Access Compliance Report

Public Rights-of-Way

(Curb Ramps)

Intersection ID: N/A	Main Street: BROOKHILL_RD	Cross Street: N/A	Location: NW
ADA ID: 21FDF308758A	Ramp Type: PerpDiag	Initial Pass/Fail: Fail	Overall Compliance: No
Codes/Mitigation Info/Possible Solution		Field Measurements/Component Compliance	
Severity Score: 28.75

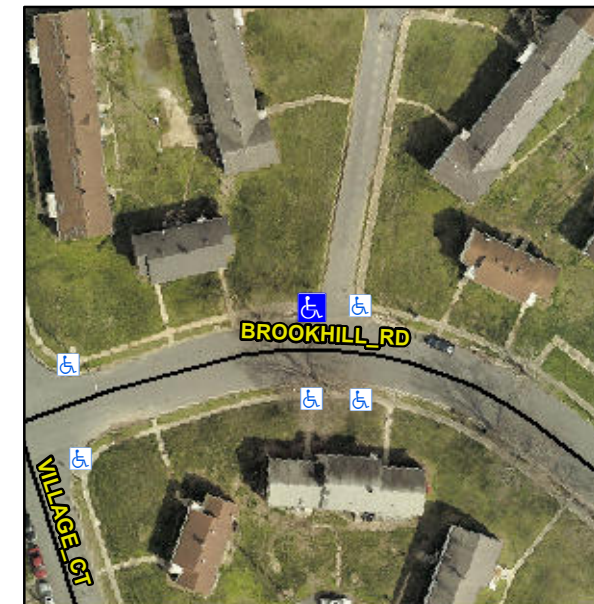
Compliance	Description	Data	Compliance	Description	Data
N/A	Ramp Length (in)	35.0	No	Ramp Slope (%)	10.3
Yes	Ramp Width (in)	48.0	Yes	Ramp XSlope (%)	2.4
N/A	Flare Type LT	N/A	N/A	Flare Type RT	N/A
N/A	Flare Slope LT (%)	N/A	N/A	Flare Slope RT (%)	N/A
N/A	Flare Traversable LT?	N/A	N/A	Flare Traversable RT?	N/A
N/A	Landing Length (in)	N/A	N/A	DWS Provided?	N/A
N/A	Landing Width (in)	N/A	N/A	DWS Contrast?	N/A
N/A	Landing Slope (%)	N/A	N/A	DWS Length (in)	N/A
N/A	Landing X Slope (%)	N/A	N/A	DWS Full Width?	N/A
N/A	Landing Curb? (Y/N)	N/A	N/A	DWS Offset (in)	N/A
N/A	Shared Landing?	N/A			
N/A	Gutter Ponding?	N/A	N/A	Gutter Slope (%)	N/A
N/A	Gutter Lip Ht (in)	5.5	N/A	Gutter X Slope (%)	N/A
N/A	Painted X Walk1?	No	N/A	Painted X Walk2?	No
	X Walk 1 Direction	To S		X Walk 2 Direction	To E
N/A	X Walk 1 Width (in)	N/A	N/A	X Walk 2 Width (in)	N/A
	X Walk 1 Slope (%)	0.3		X Walk 2 Slope (%)	6.8
	X Walk 1 X Slope (%)	8.0		X Walk 2 X Slope (%)	7.0

N/A	Ramp inside XWalk1?	N/A	N/A	Ramp inside XWalk2?	N/A
	Road Slope (%)	15.2	N/A	Clear Space?	N/A
	Road X Slope (%)	2.3	N/A	Clear Space to XWalk (in)	N/A
N/A	Any Obstructions?	N/A	N/A	Storm Grate/Utility Hazard?	N/A
	Obstruction Type			Storm Grate/Utility Type	
		N/A			N/A
		No		Surface Condition? (G/P)	Poor

Remove & Replace Curb Ramp With Two New Directional Ramps or Equivalent.
